**SUBJECT: SAFETY RECALL OF ARVINMERITOR ADAPTER PLATE BOLT
UNDER-TORQUE**

Ref.: **ARVINMERITOR NHTSA # 10E-014
MCI NHTSA # 10V-199
TRANSPORT CANADA #TC 2010-153
MCI Service Bulletins 345 & 346**

Service Bulletin No. 345

Service Bulletin No. 346

Check Hub/Rotor/Adapter Plate Bolt Torque on the Unitized Wheel Ends

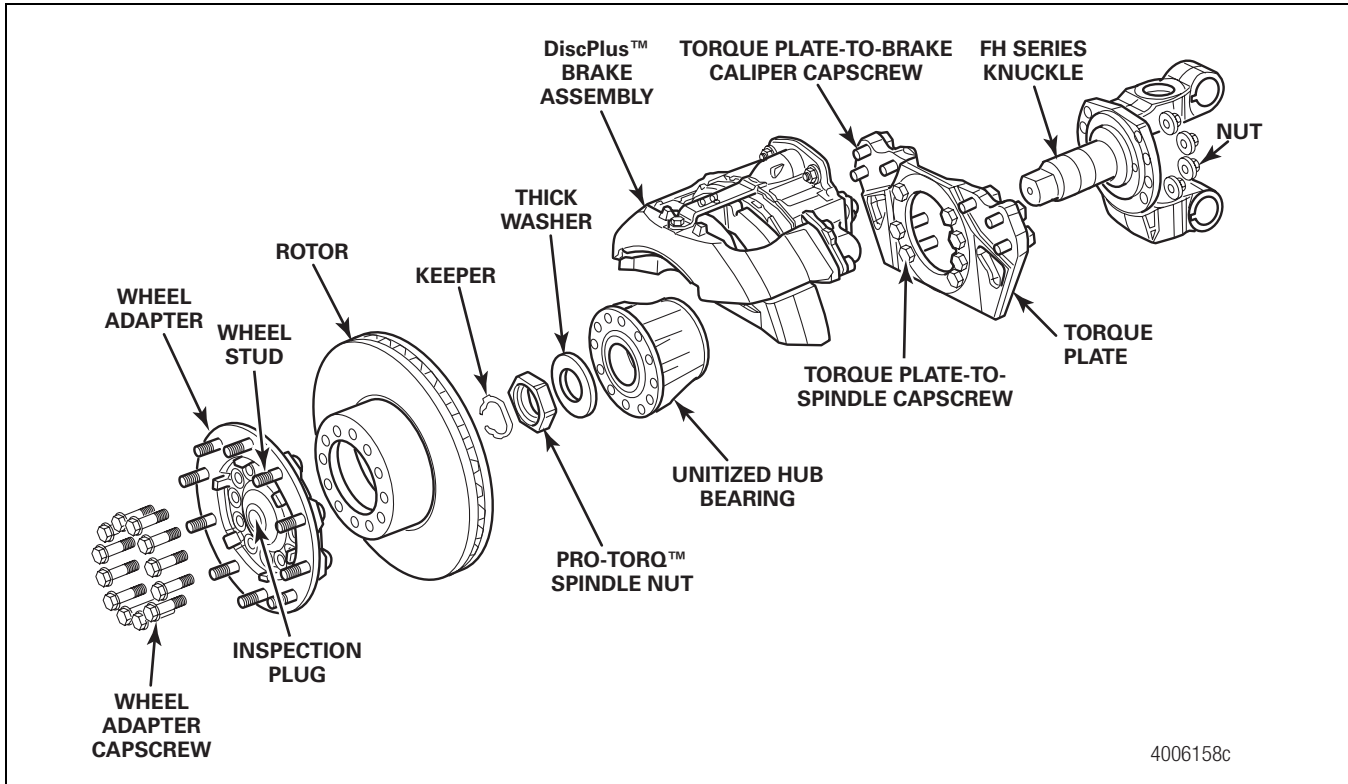
3. Use a torque wrench with a dial indicator to check hub/rotor/adapter plate bolt torque on all 12 bolts on each unitized wheel end. The bolt torque must not be less than 150 lb-ft (203 N•m). Record the torque on the Inspection Sheet included in this bulletin. 
 - If hub/rotor/adapter plate bolt torque on any one of the 12 bolts on each unitized wheel end is less than 150 lb-ft (203 N•m): Replace the bolt using ArvinMeritor part number 10X1711. Discard the bolts that were removed. Do not reuse old bolts. Record the bolt replacement on the Inspection Sheet included in this bulletin.

- If any two or more bolts in the same bolt circle on a wheel end are less than 150 lb-ft (203 N•m): Replace all 12 bolts on the untized wheel end using ArvinMeritor part number 10X1711. Remove, replace and tighten each bolt one at a time to maintain the correct clamp load on the wheel end. Discard the bolts that were removed. Do not reuse old bolts. Record the bolt replacement and torque in the Inspection Sheet included in this bulletin.

4. Use a click torque wrench to tighten all remaining bolts and any replacement bolts in a star pattern to 275 ± 25 lb-ft (373 ± 34 N•m). Record the torque on the Inspection Sheet included in this bulletin. When you have tightened all of the bolts, recheck the torque of all 12 bolts in a star pattern. 
5. Mark a stripe on all of the tightened bolts. Use a different color than the color already used.

Check Hub/Rotor/Adapter Plate Bolt Torque on the Unitized Wheel Ends

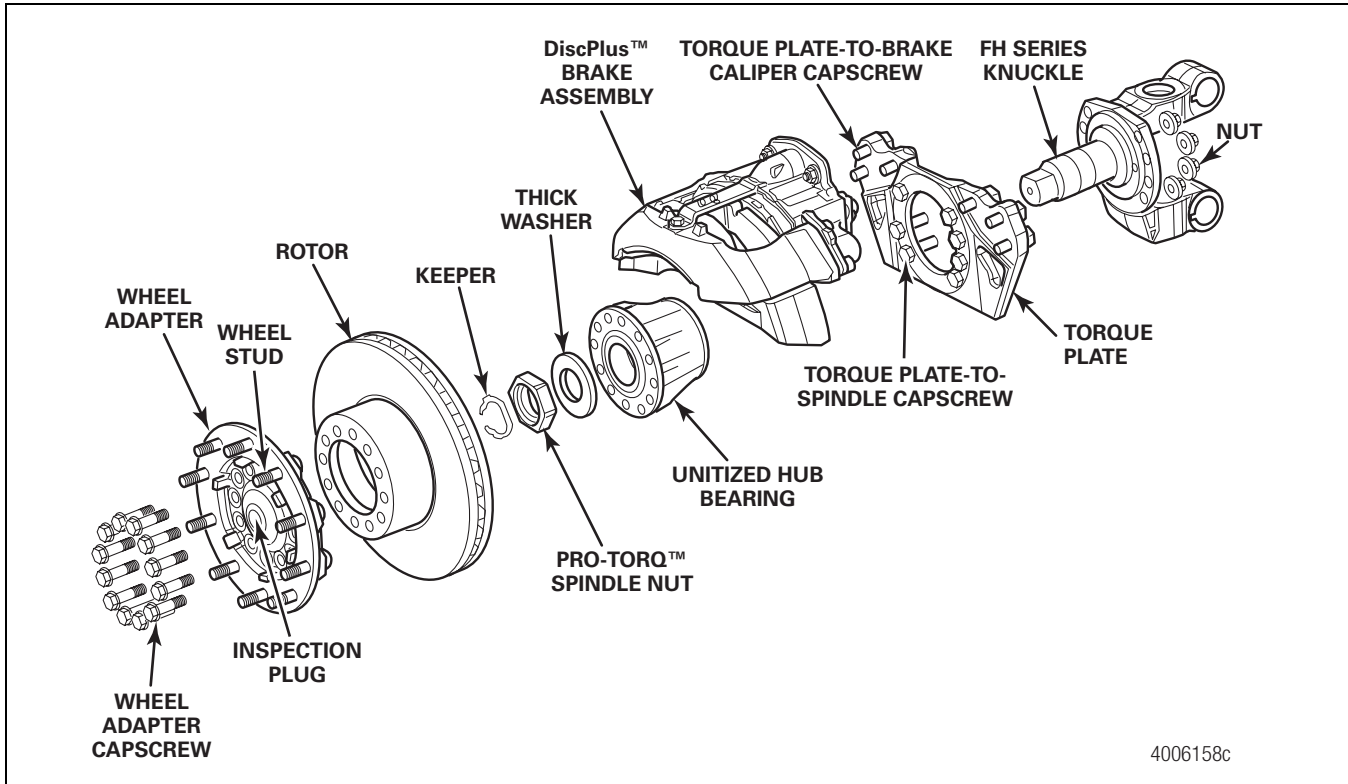
3. Use a torque wrench with a dial indicator to check hub/rotor/adapter plate bolt torque on all 12 bolts on each unitized wheel end. The bolt torque must not be less than 150 lb-ft (203 N•m). Record the torque on the Inspection Sheet included in this bulletin. 
 - **If hub/rotor/adapter plate bolt torque on any one of the 12 bolts on each unitized wheel end is less than 150 lb-ft (203 N•m):** Replace the bolt using ArvinMeritor part number 10X1711. Discard the bolts that were removed. Do not reuse old bolts. Record the bolt replacement on the Inspection Sheet included in this bulletin.

- If any two or more bolts in the same bolt circle on a wheel end are less than 150 lb-ft (203 N•m): Replace all 12 bolts on the untized wheel end using ArvinMeritor part number 10X1711. Remove, replace and tighten each bolt one at a time to maintain the correct clamp load on the wheel end. Discard the bolts that were removed. Do not reuse old bolts. Record the bolt replacement and torque in the Inspection Sheet included in this bulletin.

4. Use a click torque wrench to tighten all remaining bolts and any replacement bolts in a star pattern to 275 ± 25 lb-ft (373 ± 34 N•m). Record the torque on the Inspection Sheet included in this bulletin. When you have tightened all of the bolts, recheck the torque of all 12 bolts in a star pattern. 
5. Mark a stripe on all of the tightened bolts. Use a different color than the color already used.
